February 11, 2020 Planning Board Meeting

OFF HIGHLAND AVE/ABBY ROAD SUBDIVISION

TO: Winchester Planning Board
FROM: Beth Rudolph, PE, Town Engineer *BER*
DATE: February 6, 2020
RE: Abby Road Subdivision – Request for Release of Lots

Attachment 1

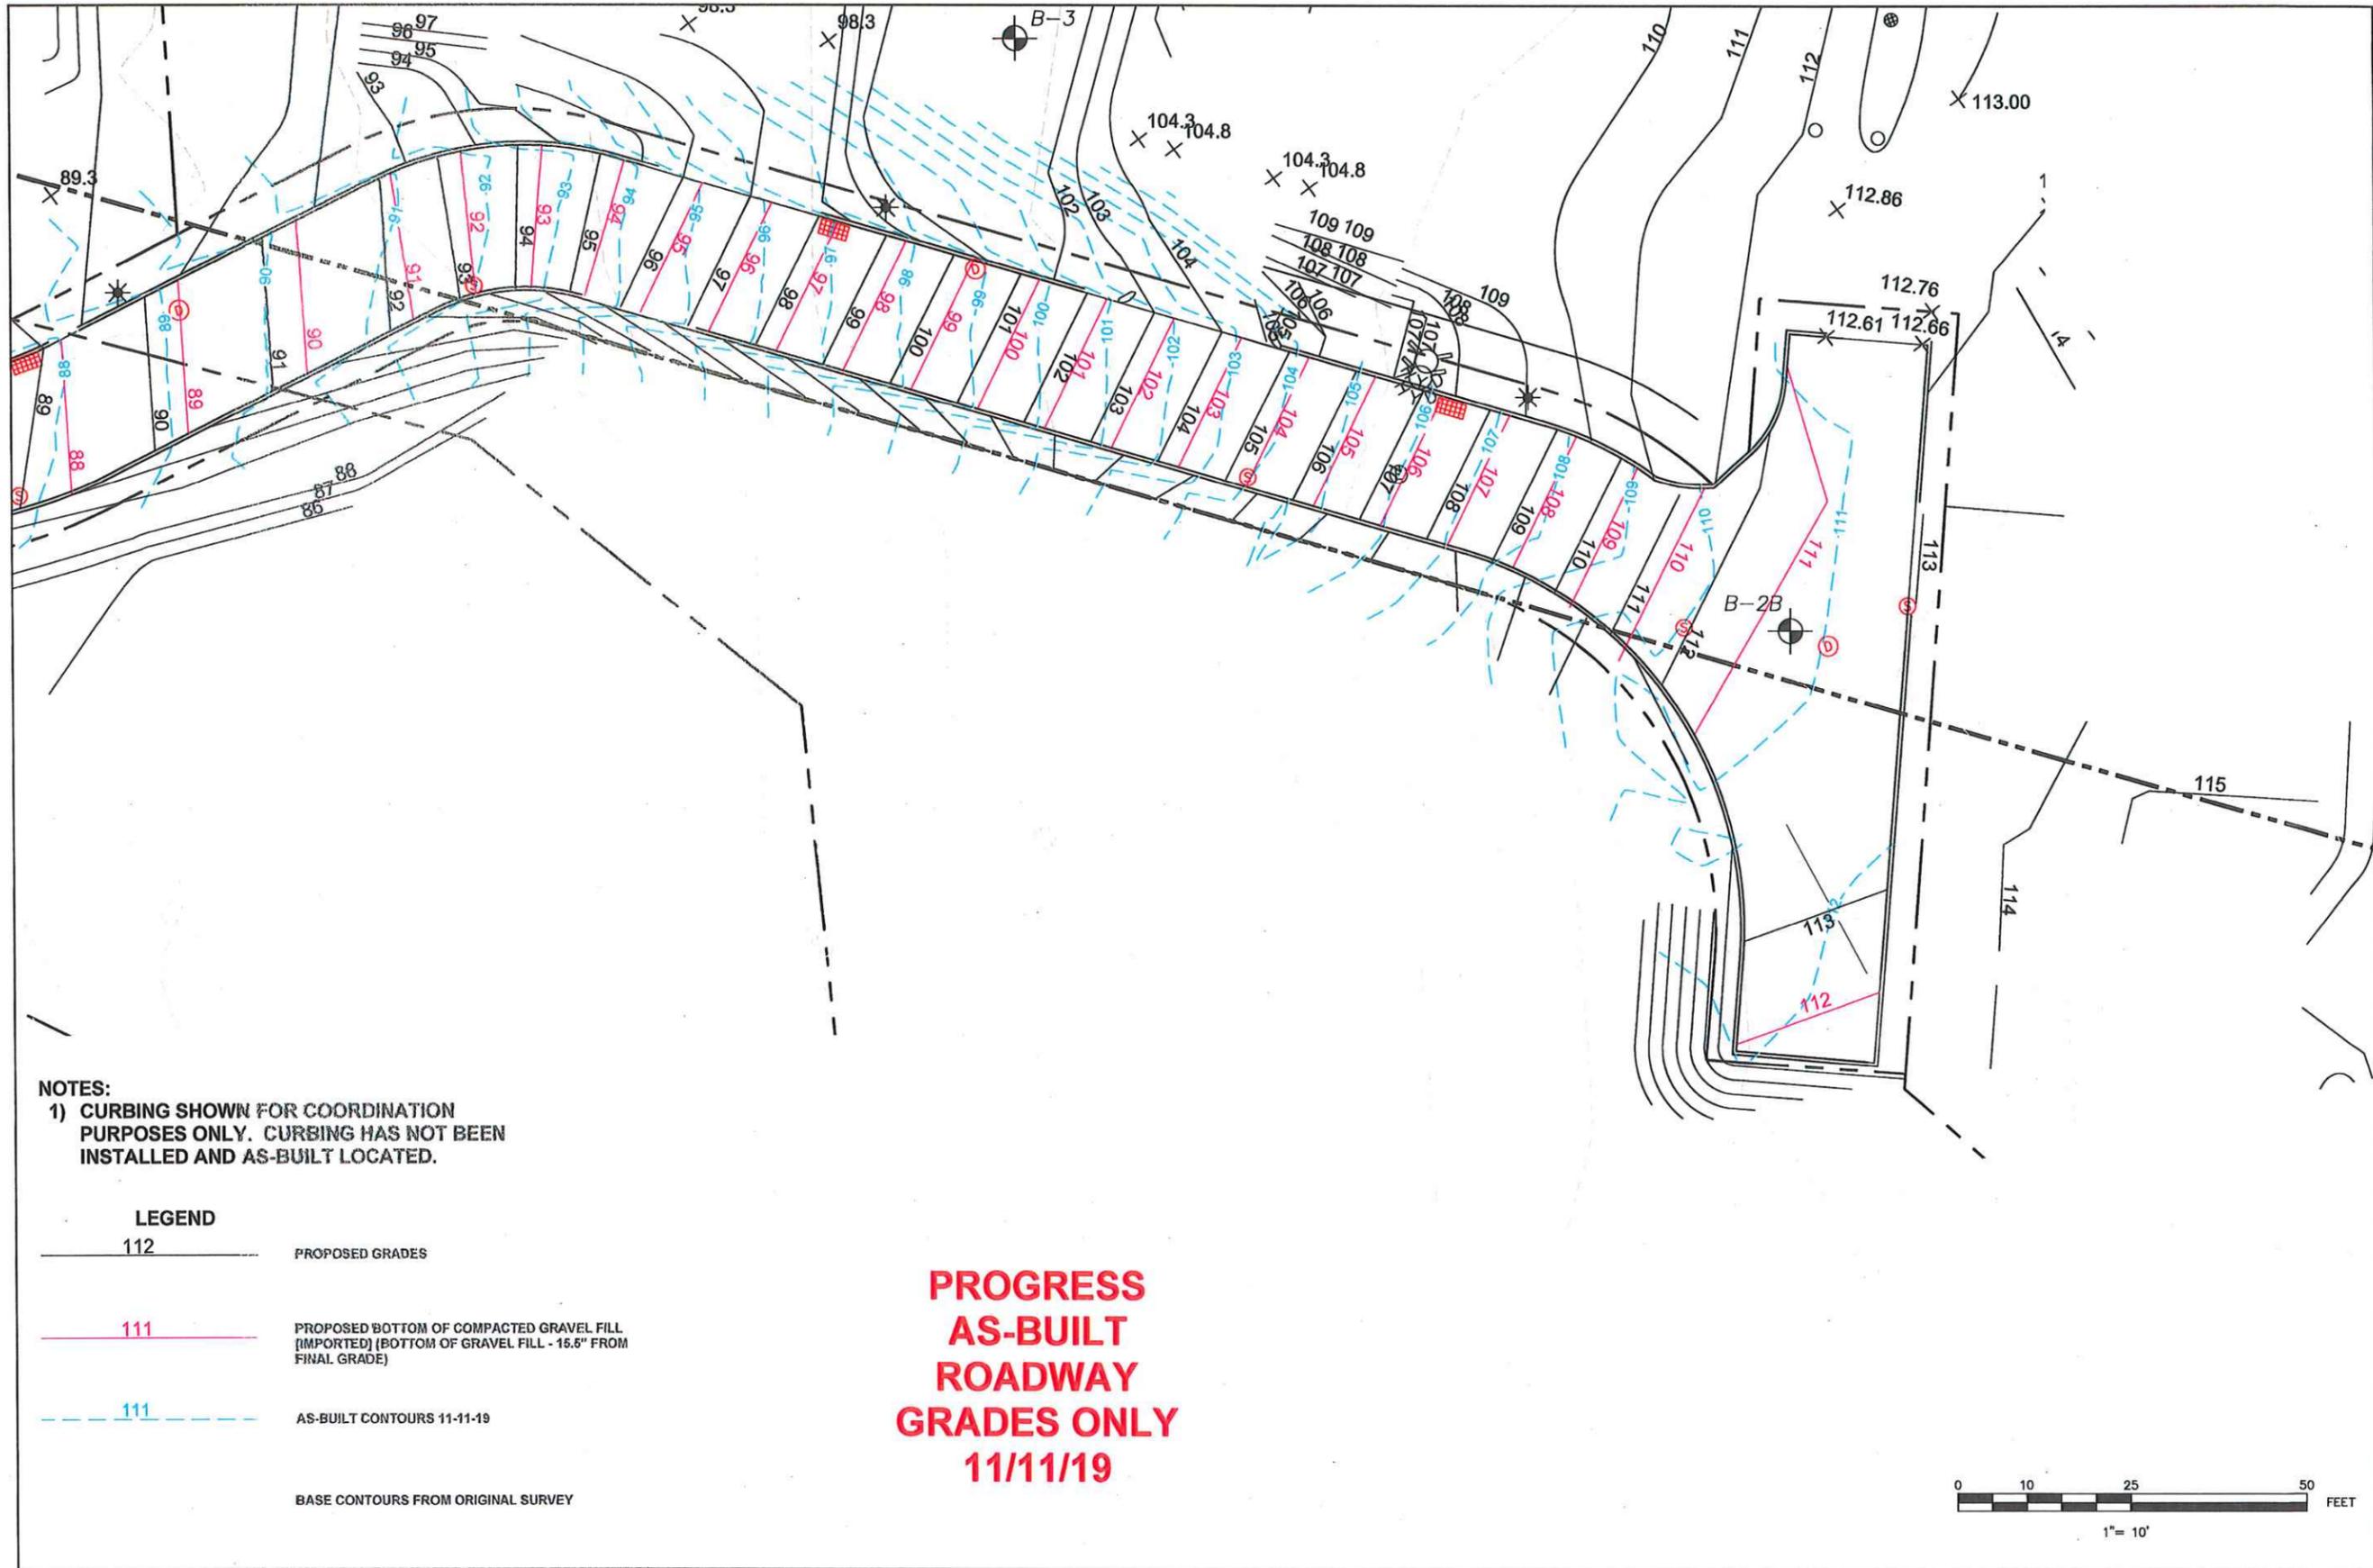
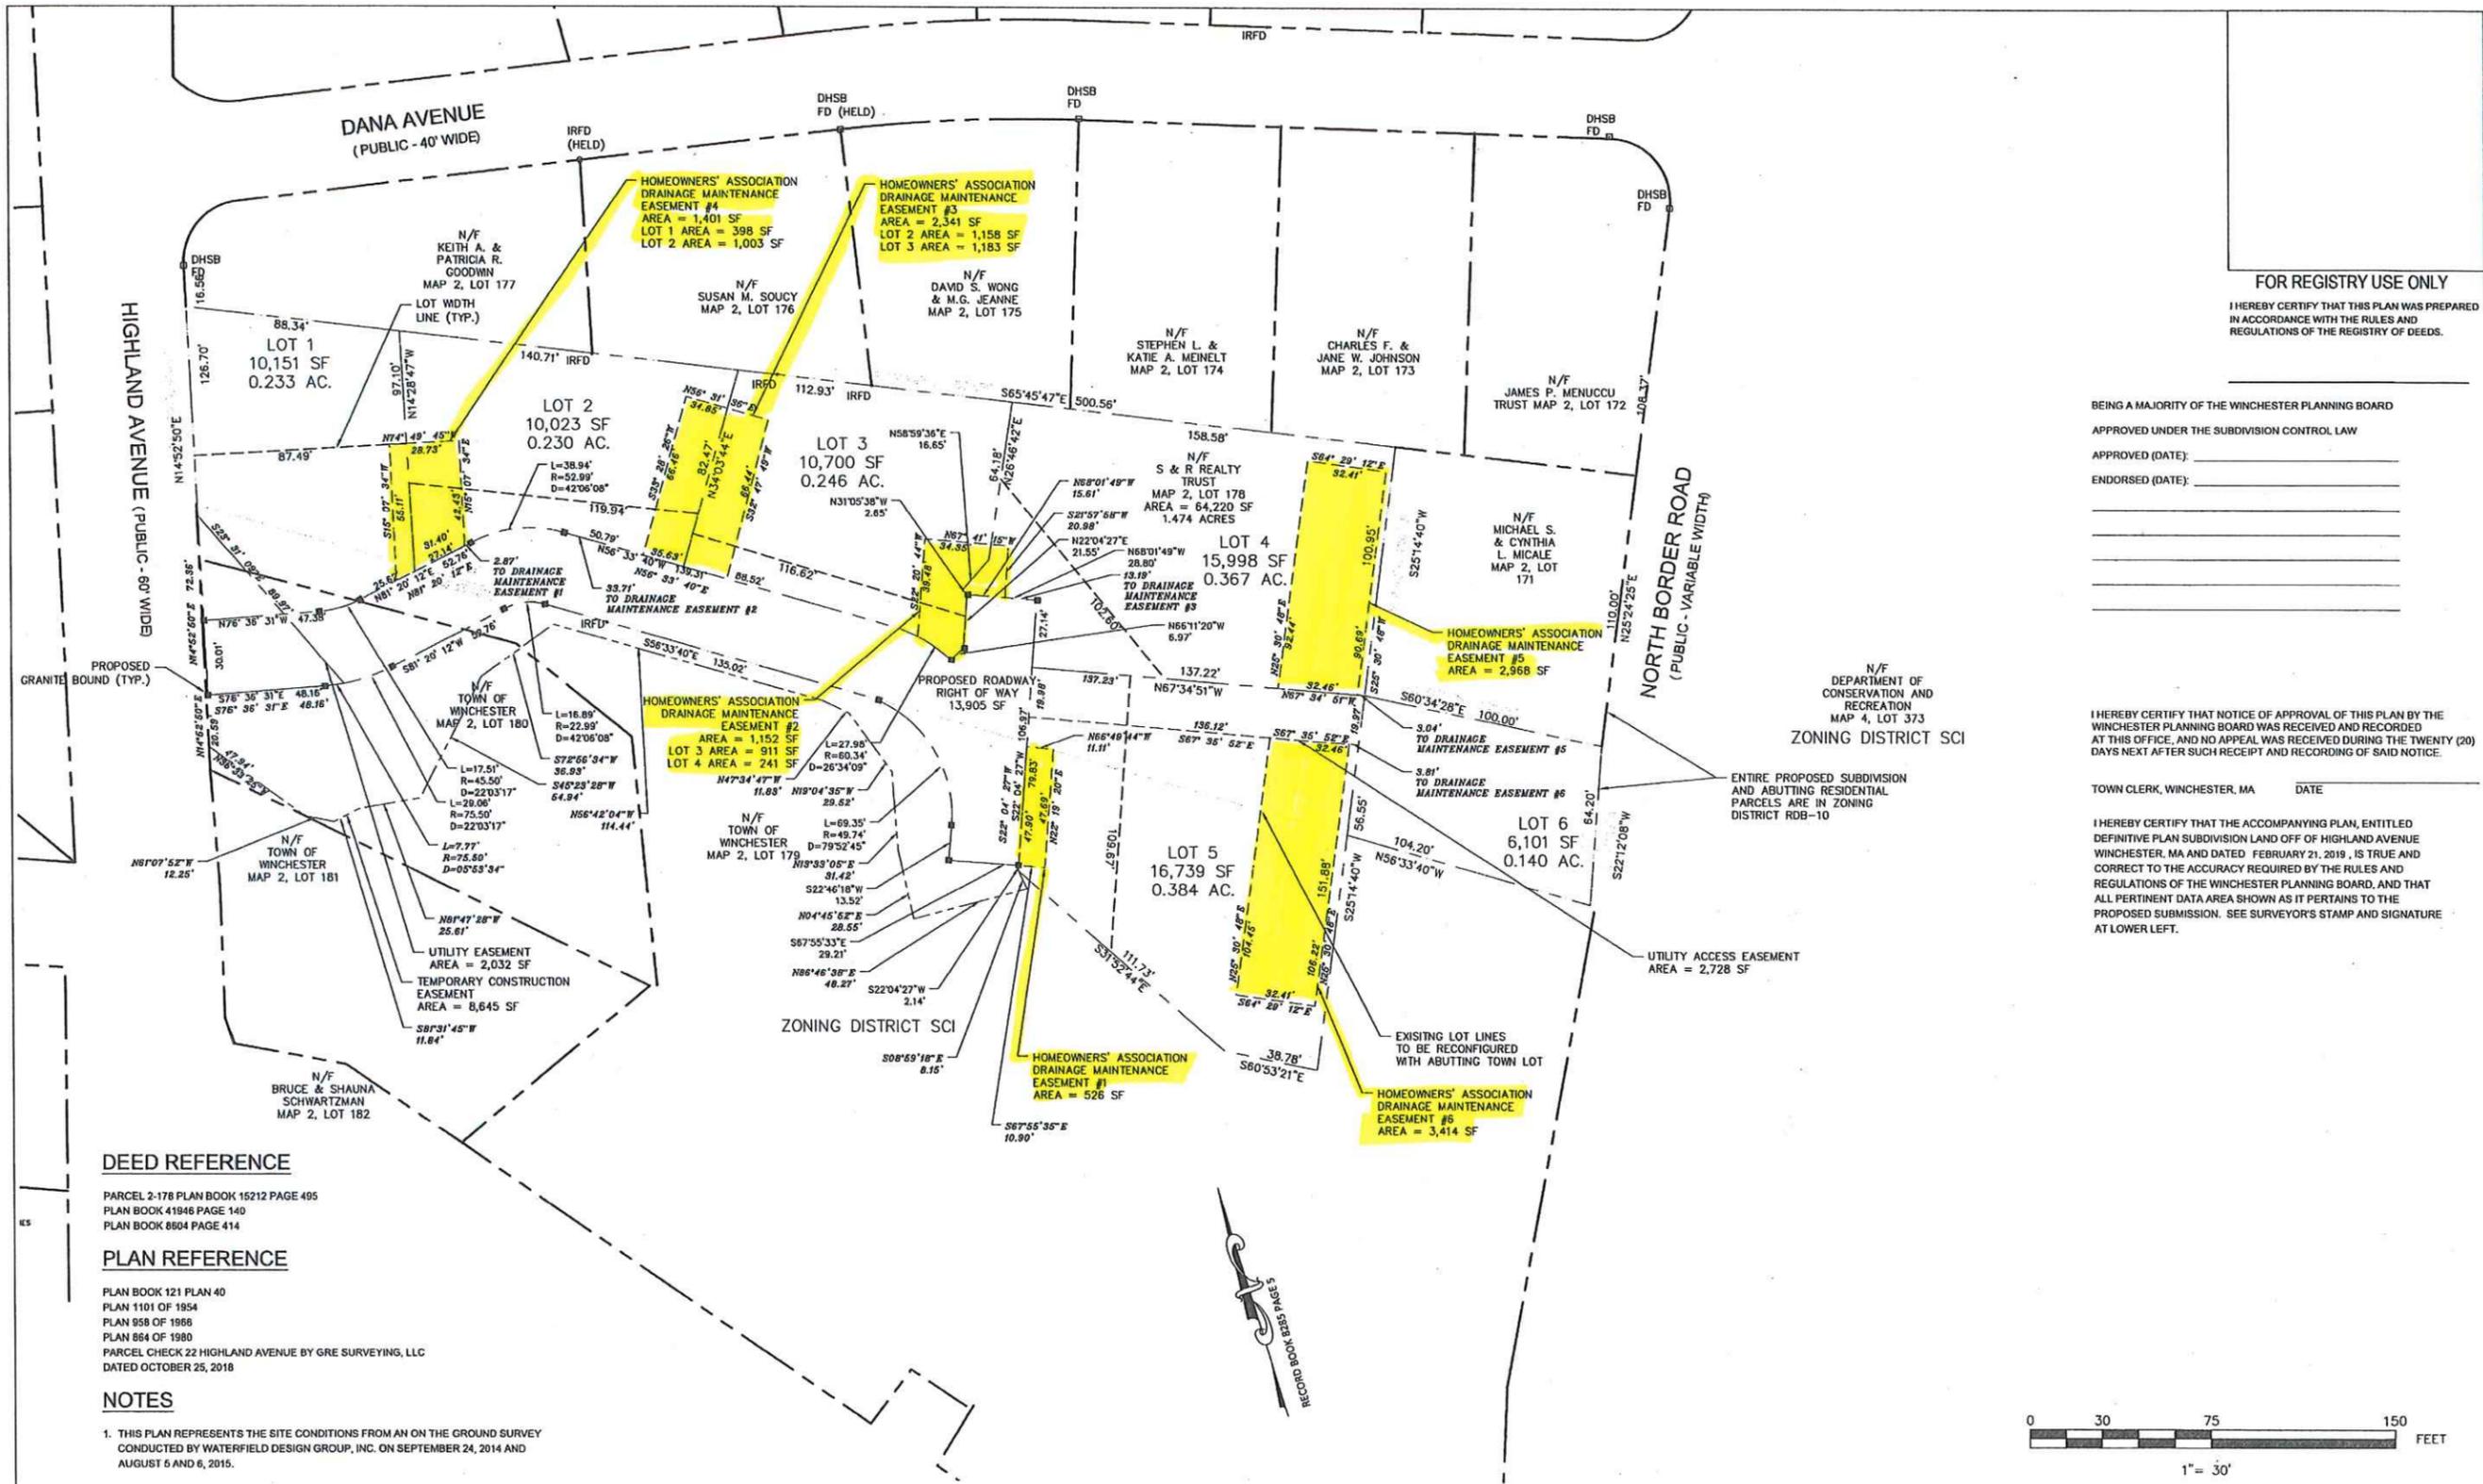
- (5) Interim As-built Plans – Prior to the release of the lots, the applicant should be required to provide an updated interim as-built plan for the project in accordance with the requirements of Section 7.21 of the Subdivision Regulations. The plans must be stamped by a Professional Land Surveyor and Professional Engineer, and include the certifications outlined in Section 7.21.2 of the Subdivision Regulations. Previous interim as-built plans were received on September 30 and November 11, 2019 (Attachment 1), but were not stamped nor did they include this certification.

Attachment 2

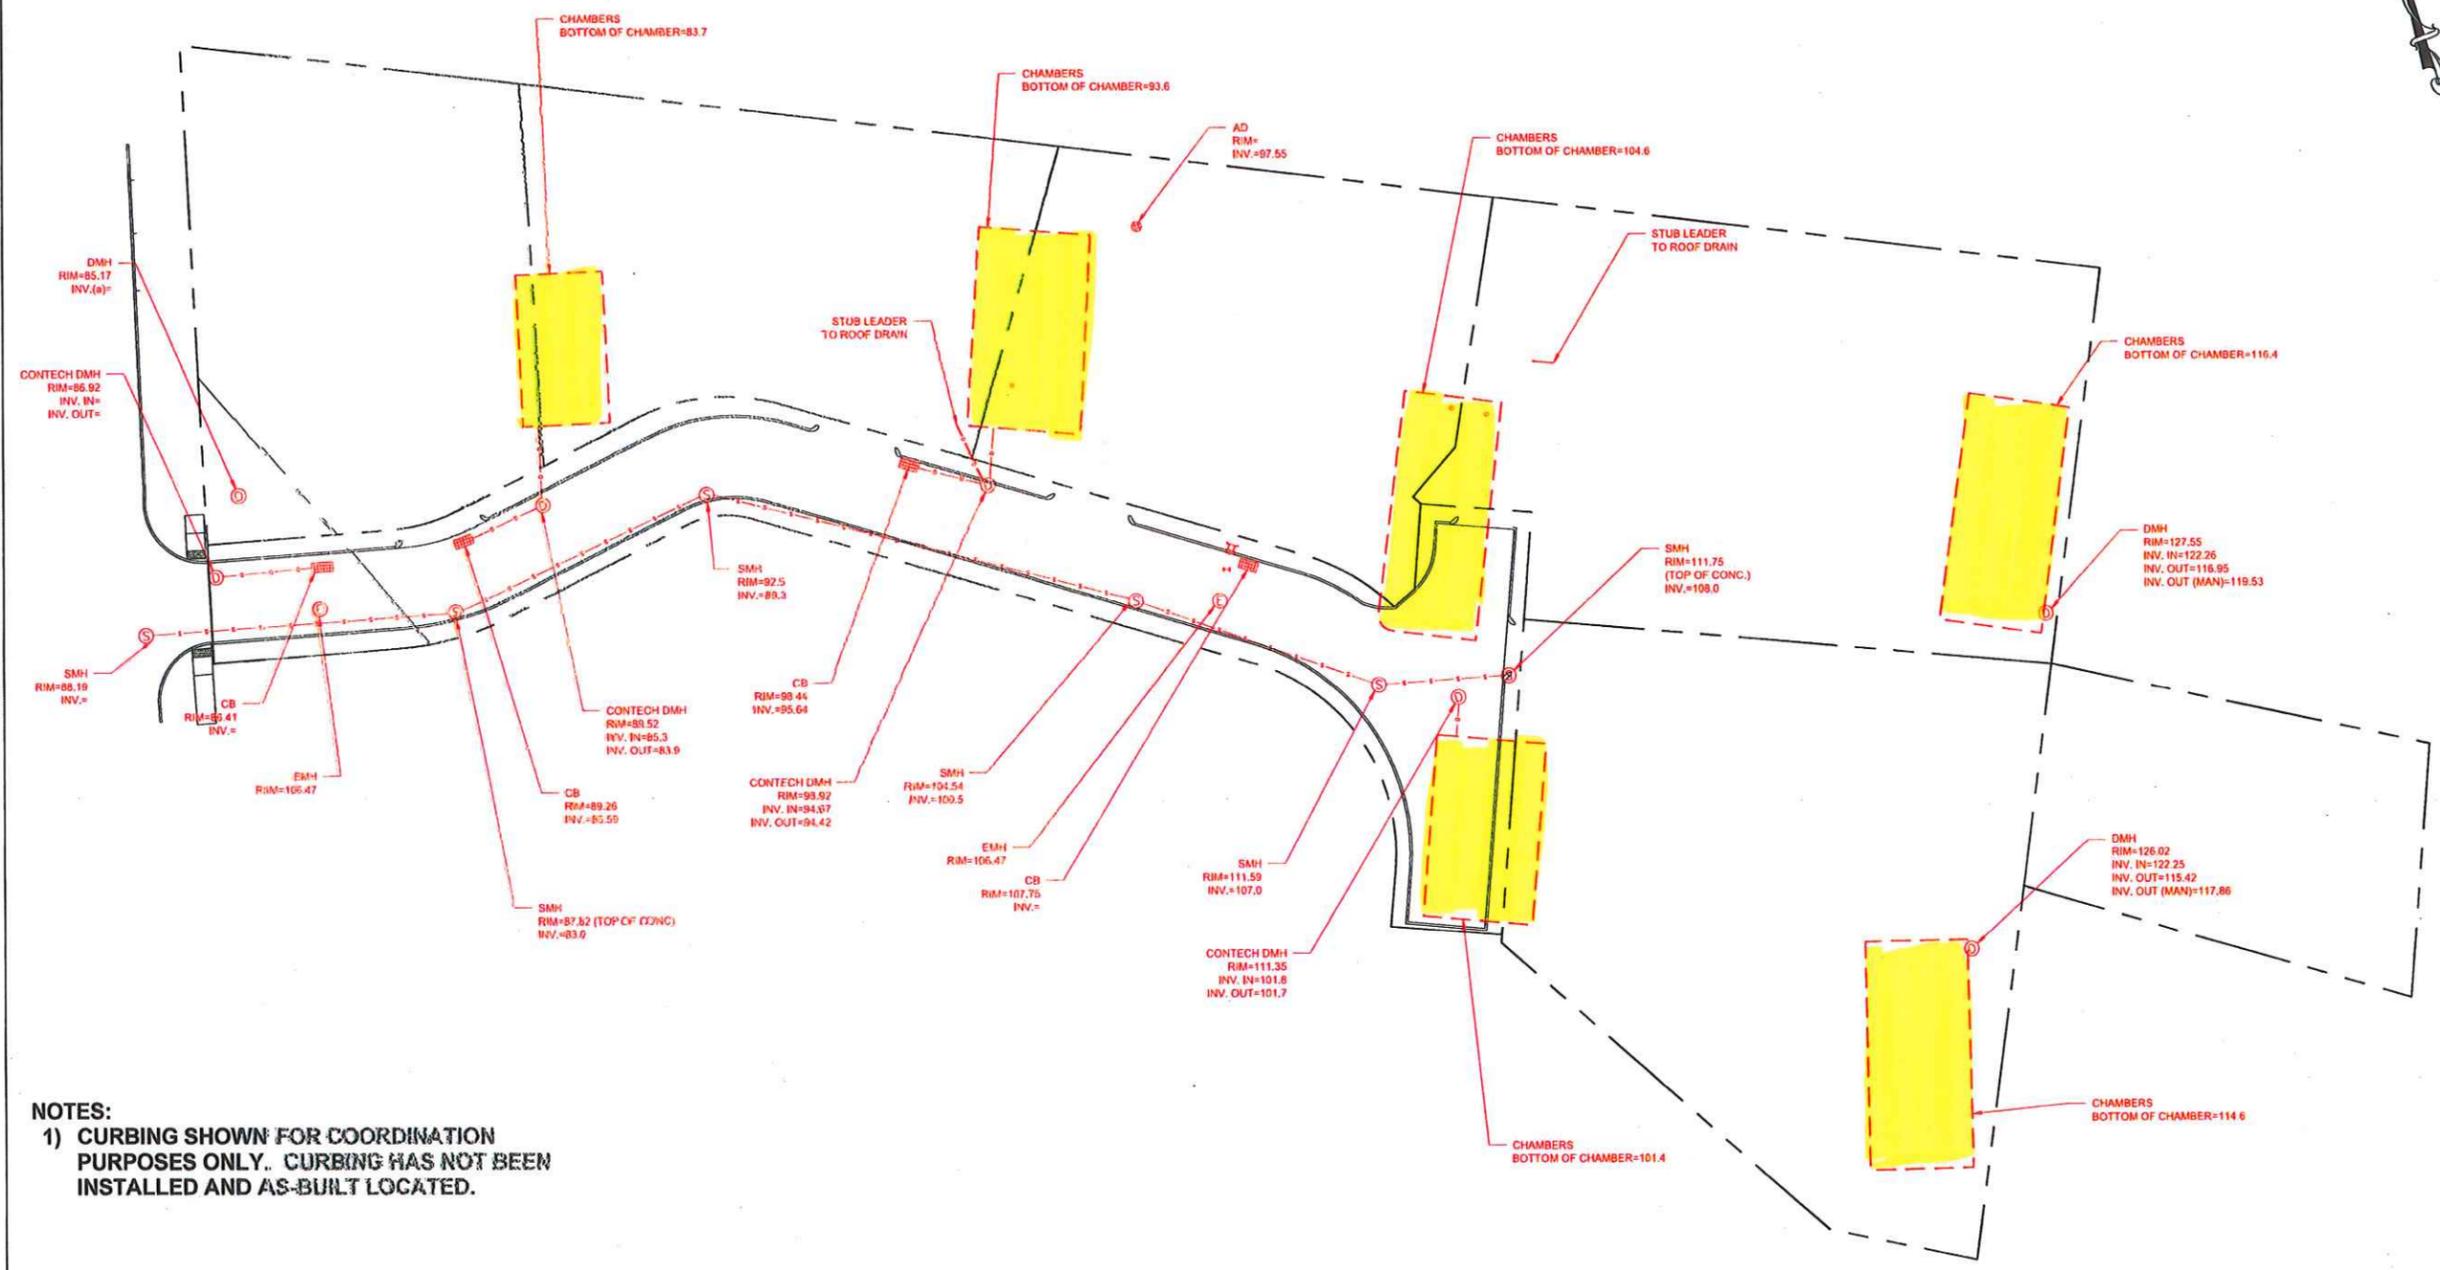
- (6) Utility Easements – Over the past year, the applicant has made several changes to the design of the underground infiltration systems associated with the project. These changes were previously approved by the Engineering Department. Comparing the as-built plans provided on September 30, 2019 to Sheet S-1 of the approved subdivision plans, it appears that the infiltration systems have not all been installed fully within the easement areas laid out in the approved plans. The applicant should provide the Engineering Department with a plan overlaying the as-built location of the infiltration systems and other utilities on Lots 1 – 5 with the utility easements shown on Sheet S-1 (Attachment 2) of the approved subdivision plans. If the infiltration systems as constructed do not fit within the boundaries of the utility easements shown on the approved subdivision plans, the applicant will need to file new plans at the registry updating the easement boundaries. The Engineering Department recommends that this be completed before any impacted lots are released so that the deeds for sale of the lots reflect the correct utility easement locations.
